Massachusetts Department of Transportation Highway Division Longfellow Bridge Rehabilitation Task Force

Executive Summary

Two lane release into Charles Circle with no change in the abutment wall configuration:

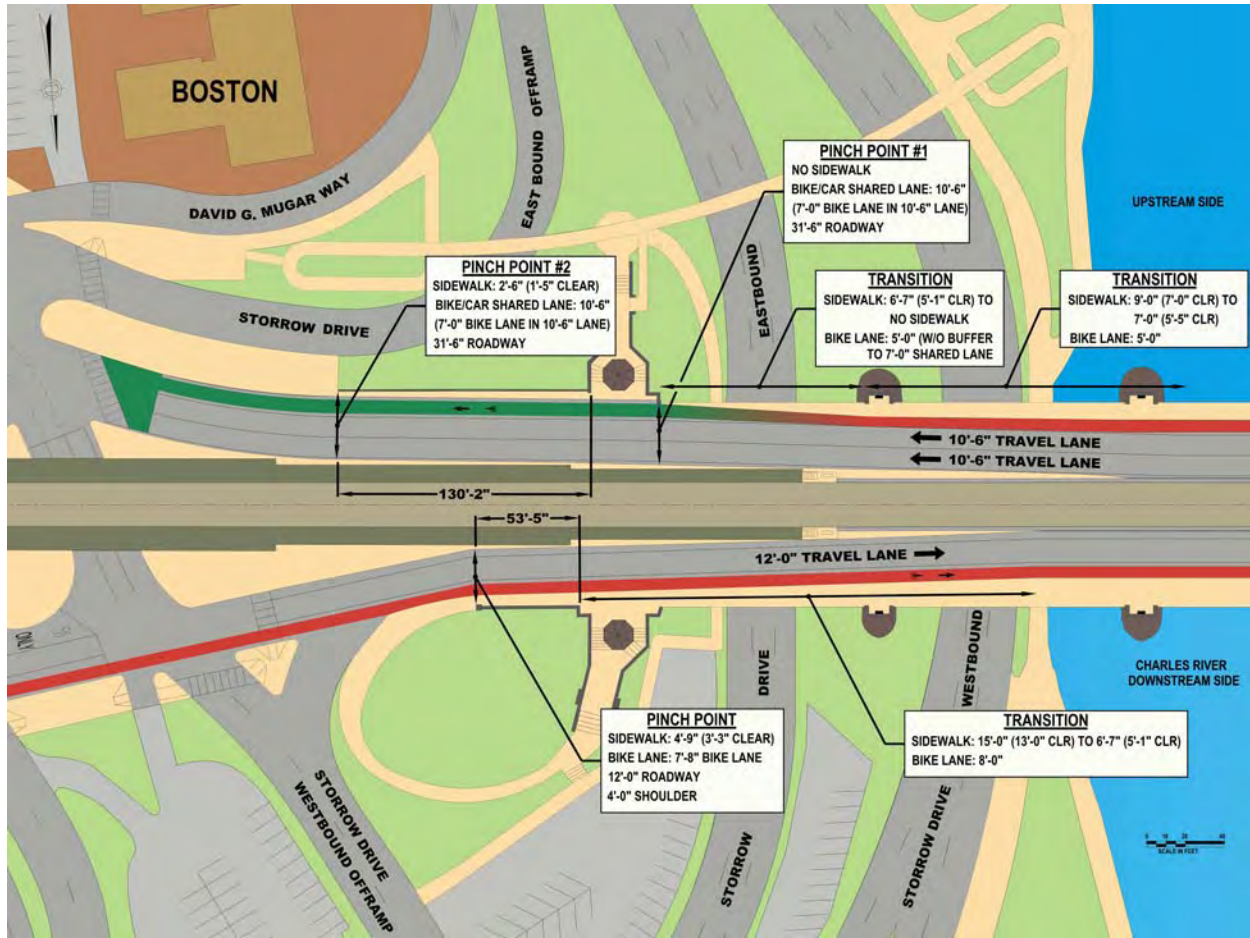
Task Force members asked for options which include both a two lane release and a three lane release into Charles Circle. For the two lane release no reconfiguration of the abutment wall is necessary. For a three lane release, reconfiguration of the abutment wall is necessary, to accommodate ADA accessible sidewalks. MassDOT has expressed a preference for relocating the abutment walls to accommodate a three lane release into Charles Circle, an ADA compliant sidewalk, and a dedicated bike lane. Furthermore, MassDOT has expressed strong confidence that it would receive all necessary approvals relating to parklands changes [often referred to as the Section 4(f) process] and has already received a "No Adverse Affect" finding relating to historic preservation [often referred to as the Section 106 process]. MassDOT and most Task Force members feel that the moving of the wall in combination with other improvements described as part of the improvements to the Cambridge approach and Esplanade connections better accommodate pedestrians and cyclists. Some members have expressed concern about whether the necessary approvals will be received.

OUTBOUND ALTERNATIVE A

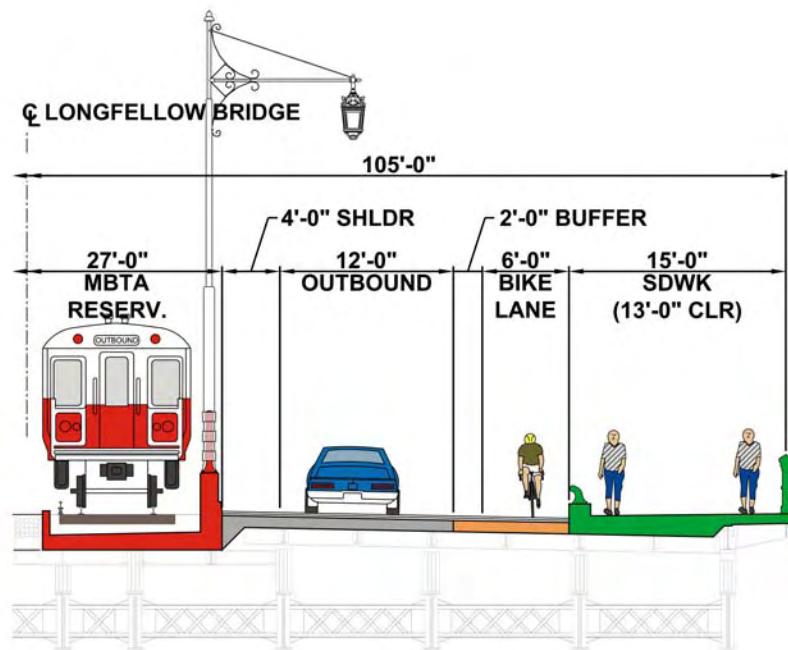
[From the MBTA reservation this alternative has a 4 foot shoulder, a 12 foot vehicle travel lane, a 2 foot buffer a 6 foot bike lane and a 15 foot sidewalk \(13 feet clear\).](#)

OUTBOUND ALTERNATIVE B

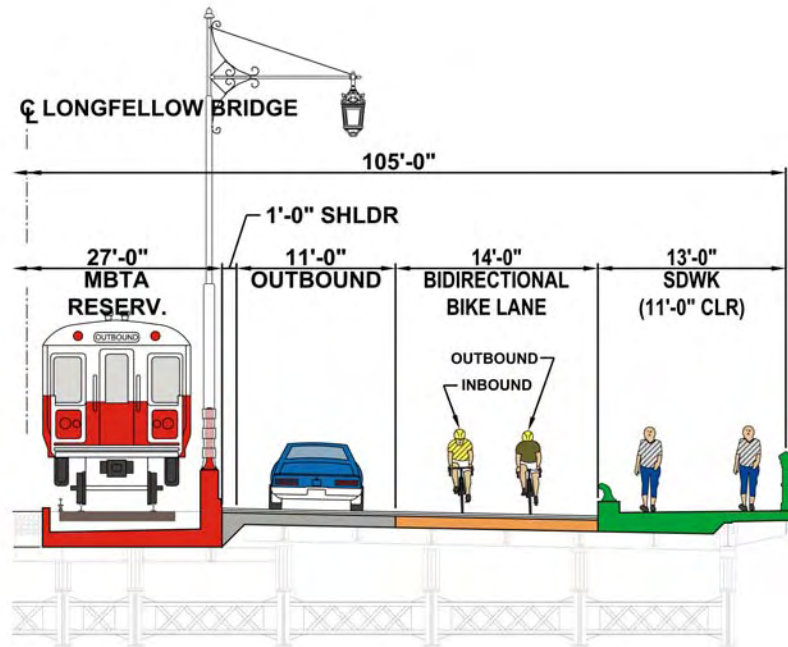
From the MBTA reservation this alternative has a 1 foot shoulder, an 11 foot vehicle travel lane, a 14' bidirectional bike lane, a 13 foot sidewalk (11 foot clear).

OUTBOUND ALTERNATIVE C

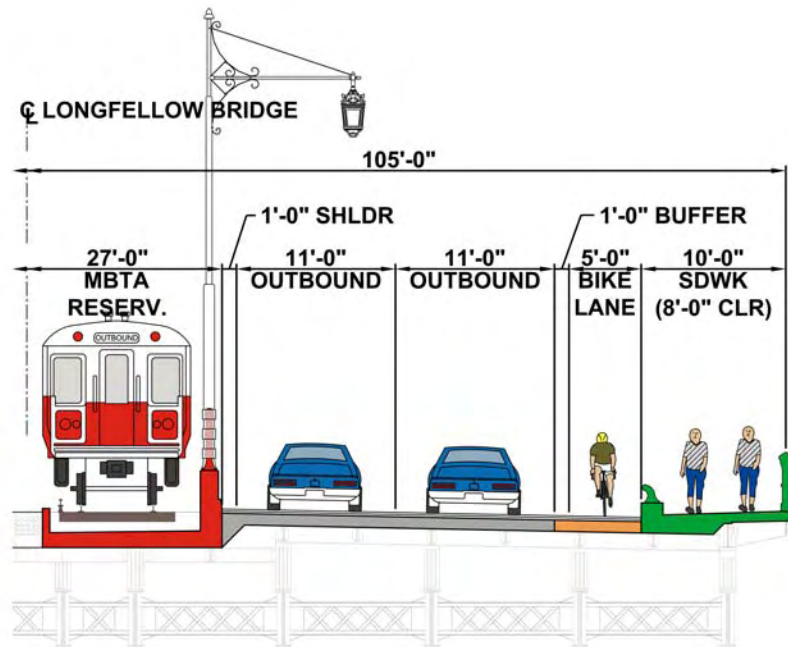
From the MBTA reservation this alternative has a 1 foot shoulder, two 11 foot vehicle travel lanes, a 1 foot buffer, a 5 foot bike lane, a 13 foot sidewalk (11 foot clear).

INBOUND ALTERNATIVE A

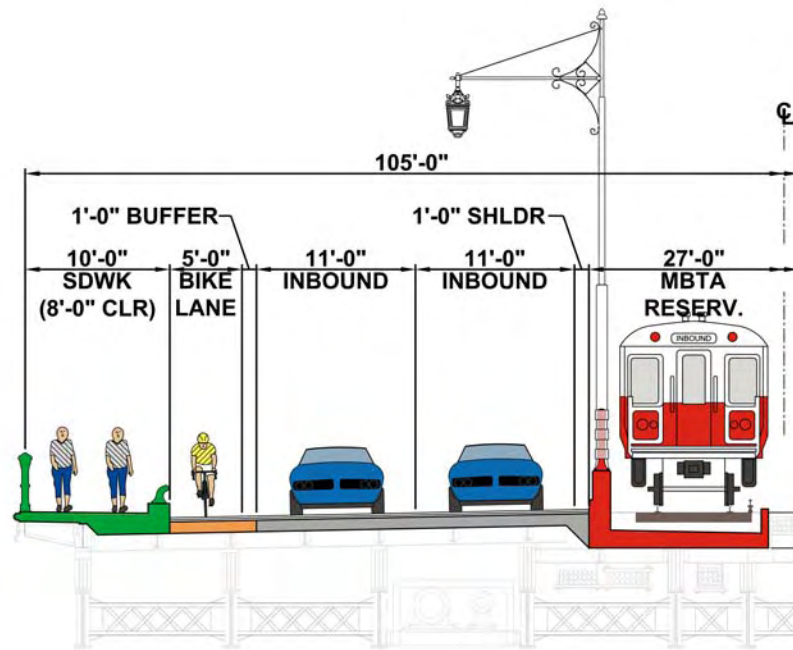
From the MBTA reservation this alternative has a 1 foot shoulder, two 11 foot vehicle travel lanes, a 1 foot buffer, a 5 foot bike lane, a 10 foot sidewalk (8 foot clear).

Alternative A represents a design that has previously received the FHWA Design Exception to reduce the lane widths from the recommended 12 foot wide lanes to 11 foot wide lanes, which provides for the MBTA's request for 11foot

[wide lanes to accommodate buses for emergency service purposes, and incorporates the bike community's willingness to agree to a 1 foot buffer between the bike lane and the vehicular lane \(although 2 ft is a more desired buffer width\).](#)

[The possible modification to this alternative is to further reduce the vehicle lane widths to 10ft 6in with the understanding that MassDOT has agreed to explore the idea of reducing the lane widths and applying for a Design Exception from FHWA. Additionally this would allow the sidewalk to be widened to 11 ft with a 9 ft clear width.](#)

VARIATION: 10'-6" MOTOR VEHICLE LANES AND 11'-0" (9'-0" CLEAR) SIDEWALK

INBOUND ALTERNATIVE B

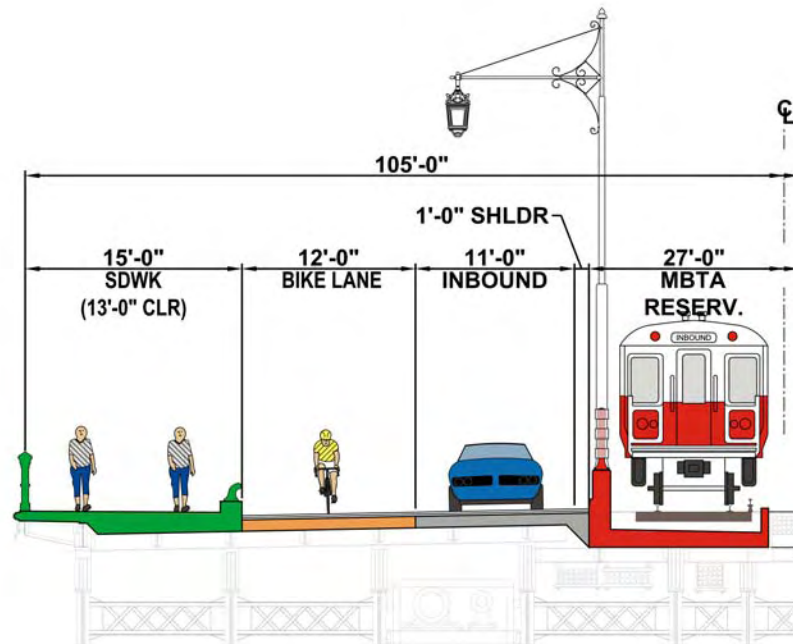
From the MBTA reservation this alternative has a 1 foot shoulder, an 11 foot vehicle travel lane, a 12 foot bike lane, a 15 foot sidewalk (11 foot clear). The understanding is that emergency use by police, police and emergency service vehicles and MBTA buses for Red Line service interruptions would be accommodated in the bike lane when required. Some members have expressed reservations that pulling to the left to allow emergency service vehicles to pass on the right could create confusion.

Inbound Alternative C

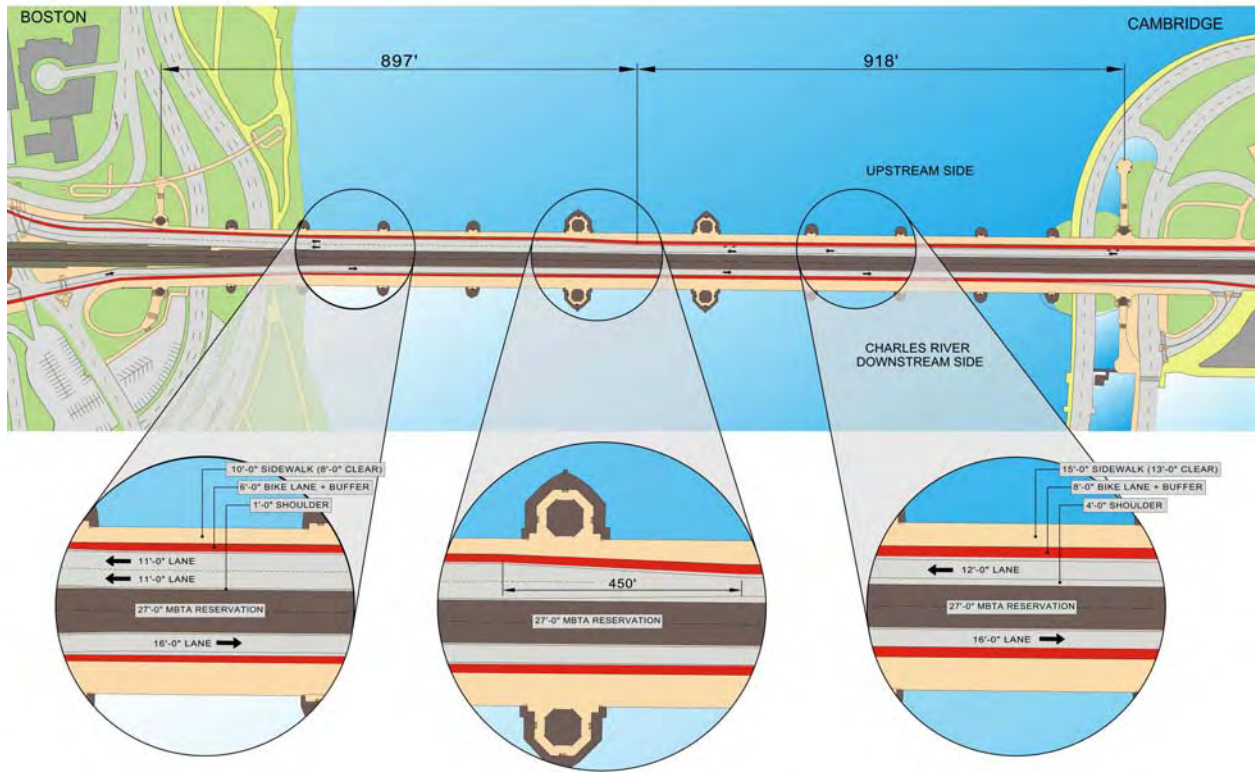
This alternative has a varying allocation of space distributed between the sidewalk and roadway, commonly referred to as the "Hourglass" configuration. The "Hourglass" configuration allocates bridge width according to the current vehicular demands for using the bridge, with a single lane carried onto the bridge from Cambridge, and widening to two lanes near the midpoint of the bridge, and finally widening further to three lanes at the entrance to Charles Circle in Boston. This alternative has two different distinct configurations, with a transitional zone located near the mid point of the bridge. The allocation of space from the MBTA reservation is as follows: 1) for the portion of the bridge coming

from Cambridge, this alternative has a 4 foot shoulder, a 12 foot vehicle travel lane, a 2 foot buffer, a 6 foot bike lane, and a 15 foot sidewalk (13 feet clear); 2) for the portion of the bridge on the Boston side of the bridge midpoint, this alternative has a 1 foot shoulder, two 11 foot vehicle travel lanes, a 2 foot buffer, a 5 foot bike lane, and a 10 foot sidewalk (8 feet clear).
